DEVELOPMENT REVIEW BOARD
SUPPLEMENTAL SUBMITTAL

Project Location: Whataburger – Volcano Rd. & 98th St.
DRB Project Number: PR-2019-002402

Bowman Consulting is in receipt of the comments dated January 12, 2022, issued by City of Albuquerque for the Whataburger restaurant at NEC of Volcano Rd. & 98th St, Albuquerque, NM 87121. Please see below for the responses to the comments:

GRADING & DRAINAGE PLAN
WHATABURGER
 NEC 98TH ST. & VOLCANO RD.
 ALBUQUERQUE, NM 87124

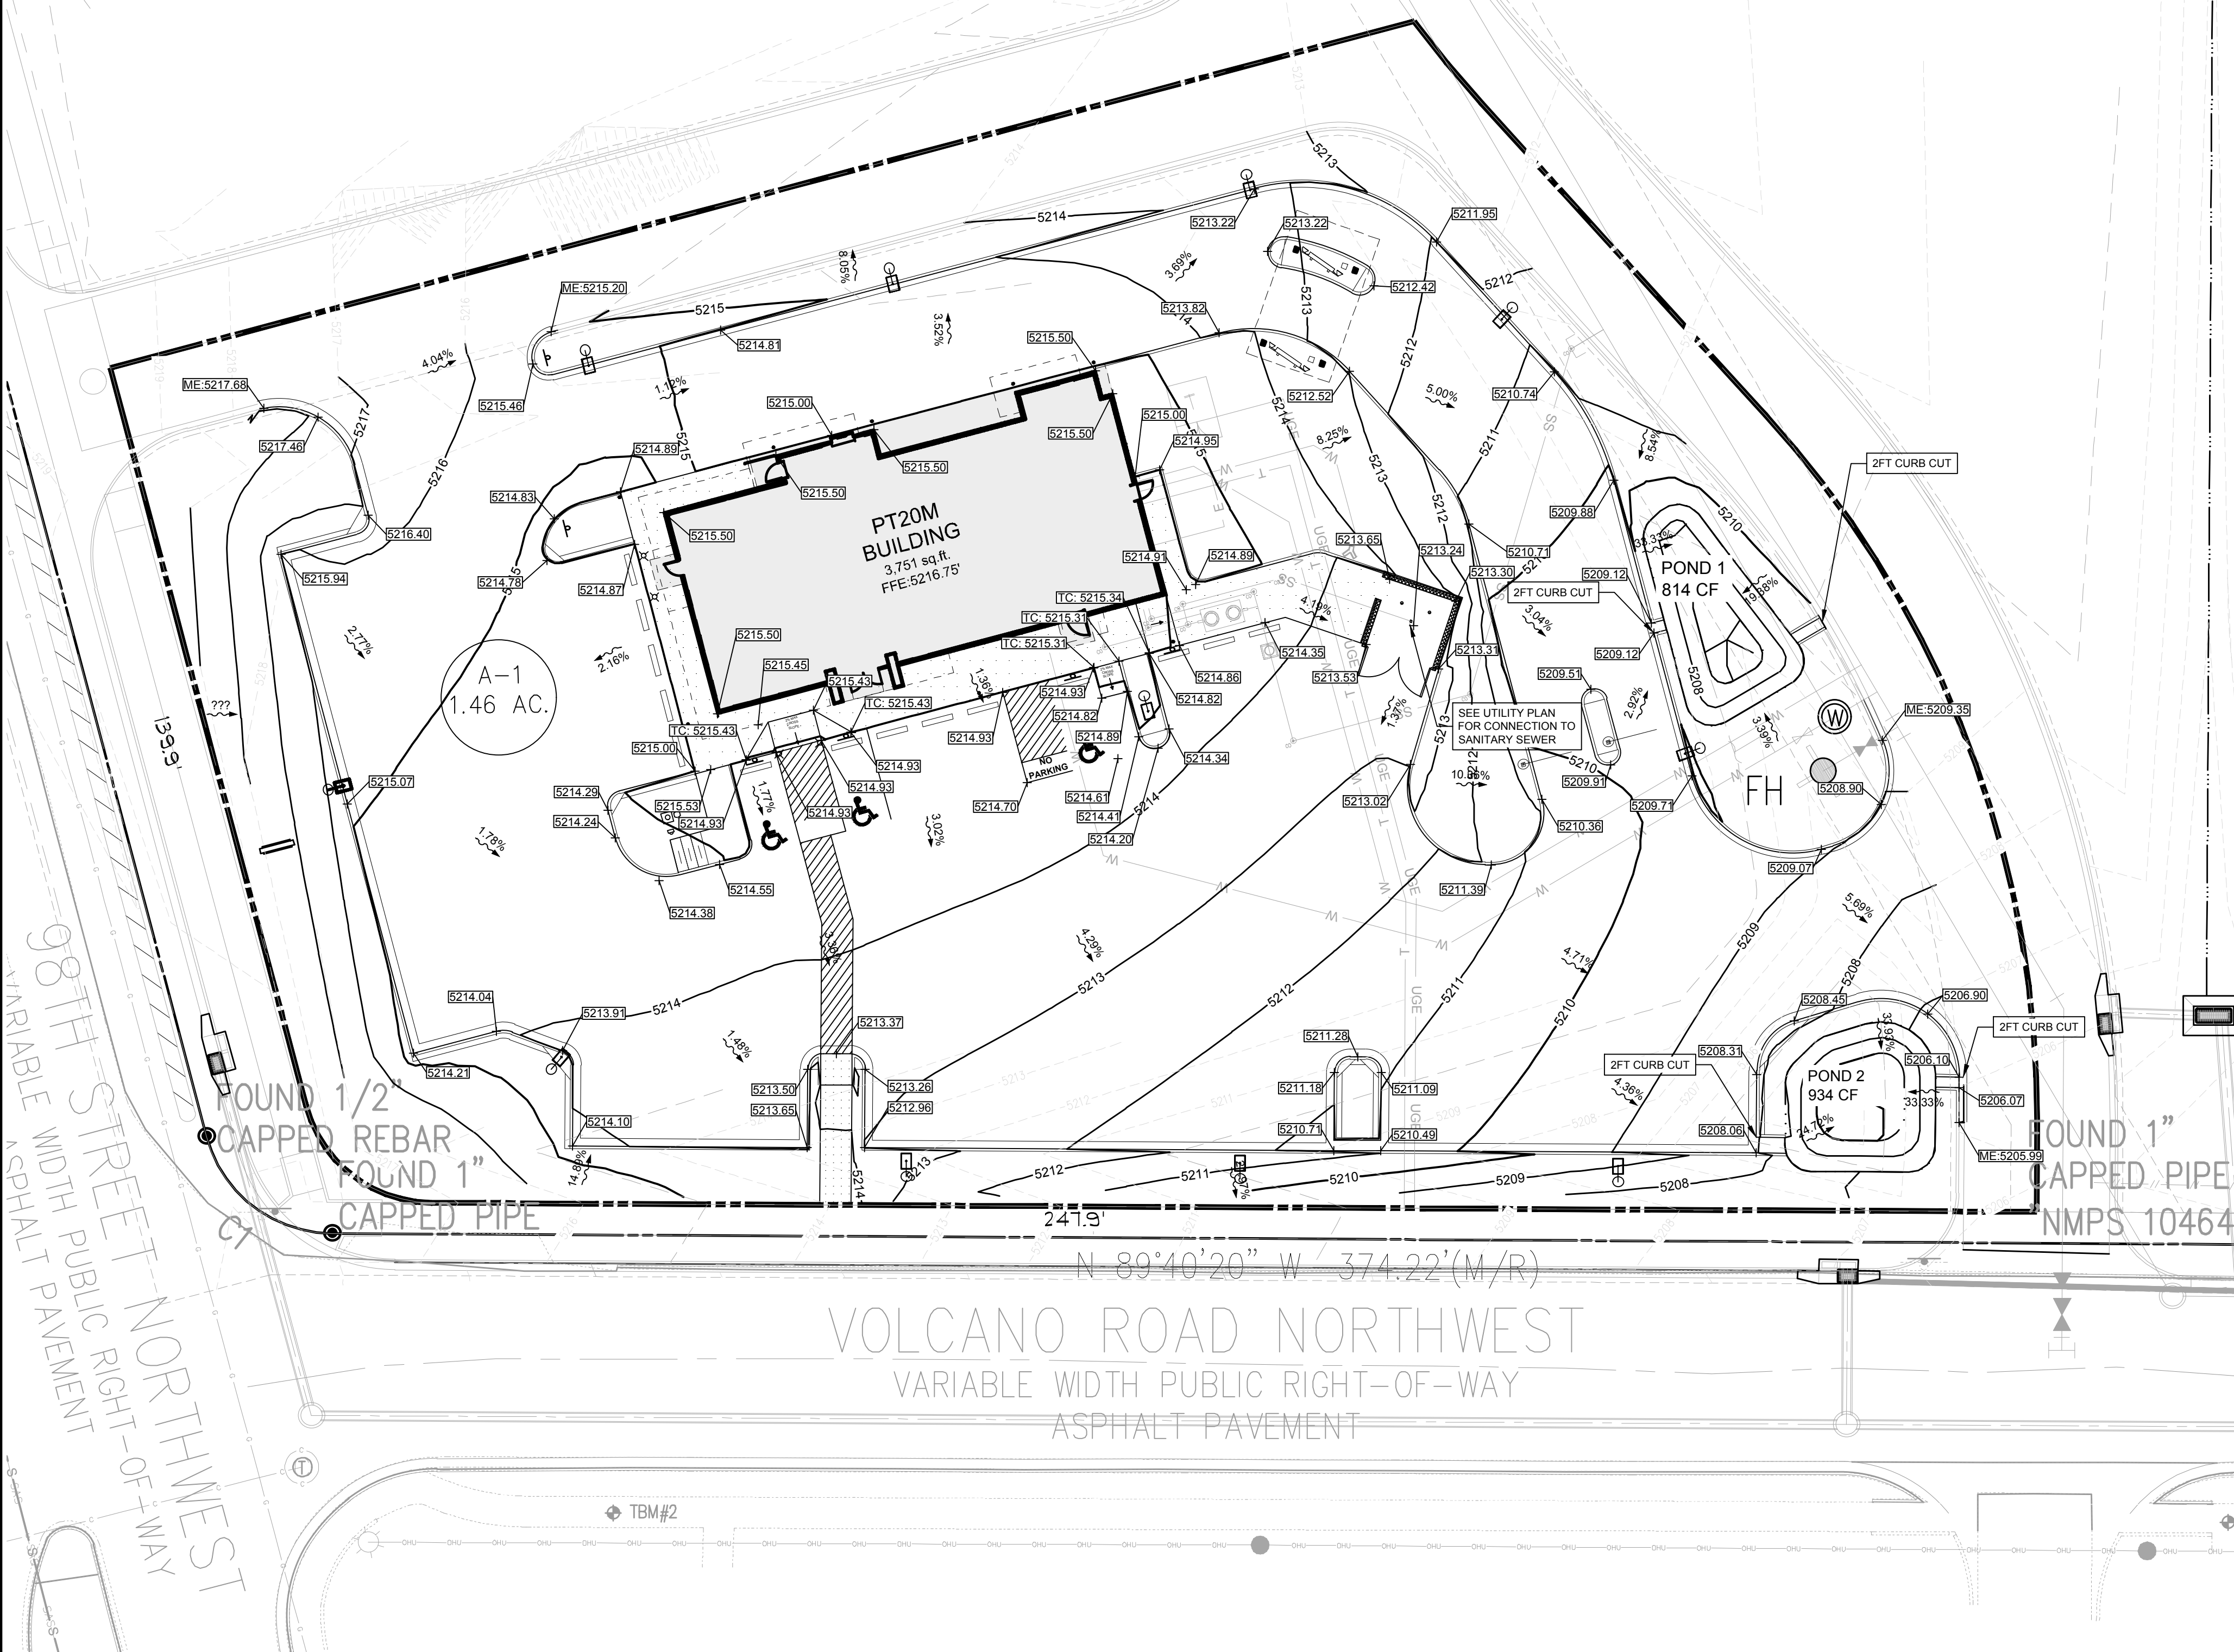
Comment 3: Sheet C4.0

The Per the Development Process Manual (DPM), the following must be on the Grading & Drainage Plan. These are items missing or on other another sheet but must be placed on the G&D.

A. Please provide an engineer's stamp with a signature and date.

B. Please use 1" = 20' for the scale.

Comment 5: For trash enclosures serving food service developments, demonstrate control of liquids from dumpster areas per DPM by containing runoff from the dumpster area, preventing outside drainage from entering the dumpster area, and discharging to the sanitary sewer. I see the discharge into the sanitary sewer, but it does appear that there is some outside drainage going into the enclosure. Also, please show the inlet and label "See Utility Plan for connection to sanitary sewer."

Comment 6: This site only needs 1,677 CF of Stormwater quality ponds. You have provided 2,641 CF but one of the ponds has sanitary sewer and water lines which typically avoided when possible and Albuquerque Bernalillo County Water Utility Authority does not as well. I suggest that this get smaller to avoid the lines or coordinate with the overall development engineer to see if the connection can be relocated out of the SWQ pond area to provide the required SWQ ponds and still meet the conditions for parking.

Comment 7: Please number the ponds and provide the volume provided for each pond. Also, please provide a 2 ft curb cut showing how the sheet flow gets into each pond and provide a 2 ft curb cut on the side that shows how the pond is discharged into the access drive (typically on the downhill side of the pond) and ultimately draining to the future inlet on Volcano Rd.

Comment 8: Please provide the weir calculations, per DPM Article 6-16(A), for the curb cuts. A coefficient of 2.7 is typically used for the weir equation $Q = CLH^{2/3}$.

Response: An Engineer's stamp and dated signature have been added to the grading and drainage plan.

Response: The plan has been revised to use a 1" = 20' scale.

Response: The grading plan has been revised to contain the discharge within the trash enclosure. Required utility connection note has been added in the grading and drainage plan

Response: The pond volumes have been revised to contain 1,870 CF. Additionally, utilities have been revised and are now outside the pond area.

Response: Pond labels have been added showing pond number and volume. A 2ft curb cut has been added to both ends of the ponds.

Response: Weir calculations for the curb cuts have been added to the grading and drainage plan.

UTILITY PLAN
WHATABURGER
NEC 98TH ST. & VOLCANO RD.
ALBUQUERQUE, NM 87124

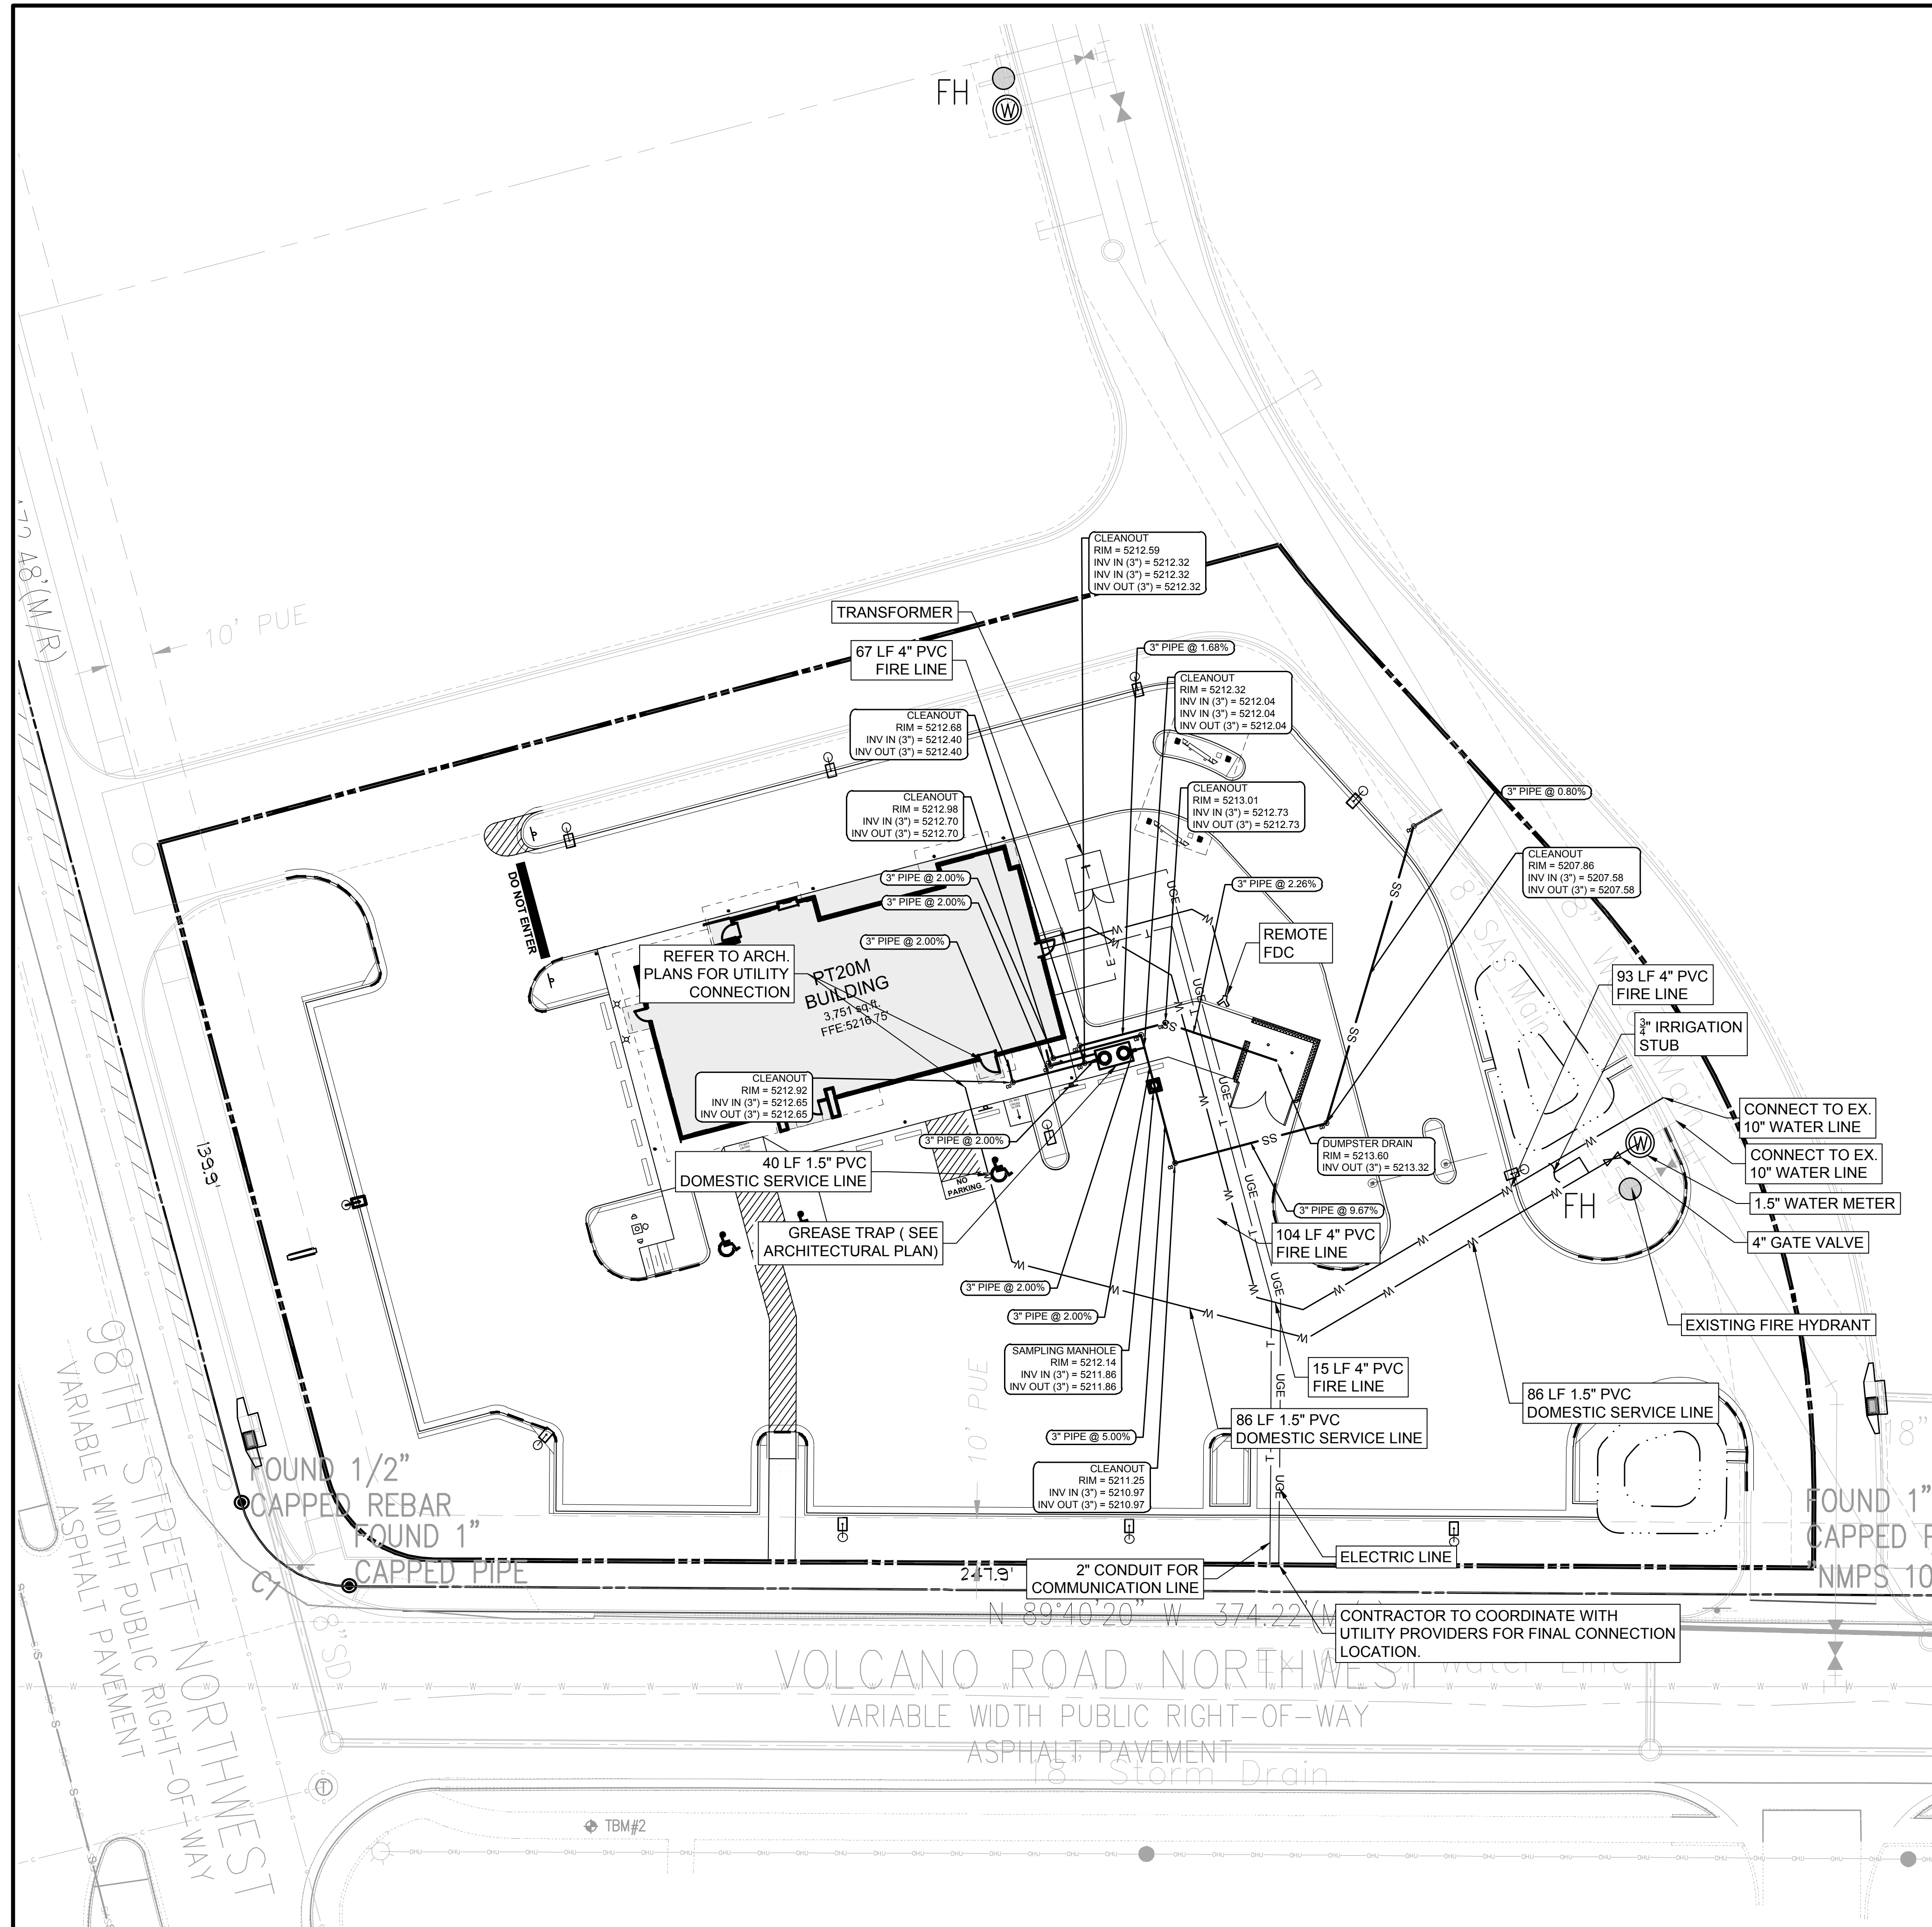
Comment 2: Sheet C6.0 Utility Plan is not needed for review and approval.

Response: Comment noted. Thank you
- Comment 3:** Pro rata is not owed for this property.
Response: Comment noted. Thank you
- Comment 4a:** The service line for the irrigation meter shall go directly to the public main. There should not be any branches from the domestic service to accommodate an irrigation meter.

Response: Comment noted. Thank you.

Response: Irrigation service has been revised to branch off after the domestic meter as recommended by City Engineer Blaine Carter.
- Comment 4b:** Consider revising the blocks from the subdivision utility plan, it appears to show a single meter in this location.
